UNITED STATES PATENT AND TRADEMARK OFFICE

APPLICATION NO.	FILING DATE	FIRST NAMED INVENTOR	ATTORNEY DOCKET NO.	CONFIRMATION NO.
09/847,605	05/01/2001	Karl Jacob Haltiner JR.	DP-302846	7187

Office Action Summary

DETAILED ACTION

FIG. 1

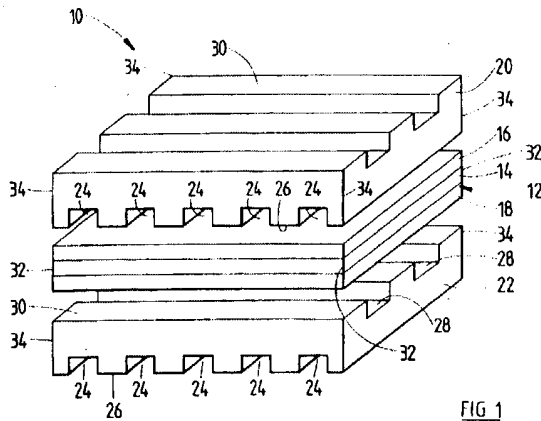
Figure 1 above illustrates a fuel cell assembly 10, the assembly comprises a fuel cell 12 comprising a solid oxide electrolyte central layer 14 with an anode layer 16 overlying one face of the electrolyte and a cathode layer 18 overlying the opposite face of the electrolyte. The fuel is sandwiched between a pair of interconnects 20, 22 which in use are in face contact with the anode 16 and cathode 18, respectively.

Figure 1 above depicts interconnects 20, 22 comprising gas flow channels 24 and 28. As can be appreciated from **Figure 1**, the interconnect comprises a plurality of top side surfaces 30 and underside surfaces 26 closely spaced to each other which act as contact points between the interconnect and electrode and wherein said top side surfaces 30 and underside surfaces 26 have small dimensional diameters. It is noted that the term, "diameter" has been construed as the

FIG. -2A

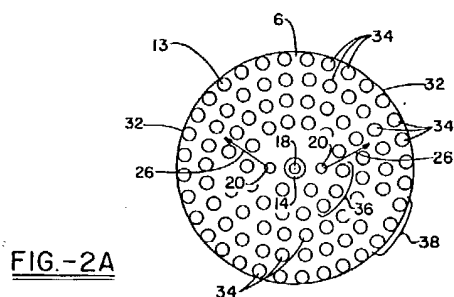
Figure 2A below shows a separator 6 defining microchannels 26 on either or both of its surfaces. Since the separators contact the anode and cathode surfaces, microchannels 26 defined

within the separator surfaces provide reactant channeling (col 6, lines 33-40). A microchannel 26 may be defined by a quantity of regularly spaced circular columns 34 (*contact points*) extending between surfaces (col 6, lines 45-48). It is disclosed that it should be understood that a preferred pattern of columns 34 would utilize many more columns than shown, with each column having a diameter on the order of about 1 mm or less (col 6, lines 58-61/col 7, lines 48-52). The cell and stack diameters are typically about 50 to about 80 mm (col 5, lines 10-12). The specific contact point density is apparent upon inspection of the separator plate 6 as illustrated in Figure 2A.

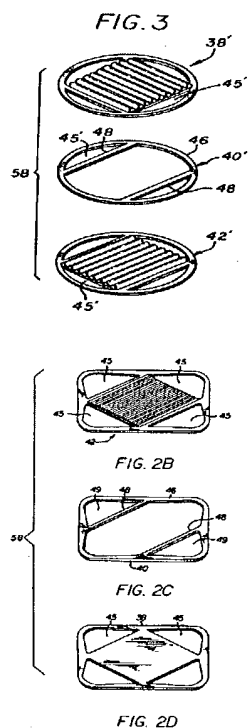
With respect to the specific flow passage depth and the surface area, it would have been obvious to one skilled in the art at the time the invention was made to make the interconnect of Badwal et al by having specified flow passage depth and surface area of Ruhl et al because Ruhl et al teaches that the specific depth of flow passage (channel) and surface area relationship should defines a channel pattern wherein the channel cross-section is enhanced such that reactant gas flowing through the passages (channel) achieves tailored local flow, pressure, and velocity distributions. Accordingly, those of ordinary skill in art would find motivation to make the specified flow passage depth and surface area relationship in the interconnect of Badwal et al as Ruhl et al teaches that such flow passage depth and surface area relationship (overall dimension), in general, achieve a specific target overall pressure drop that minimize electrical resistance and improves reactant gas distribution.
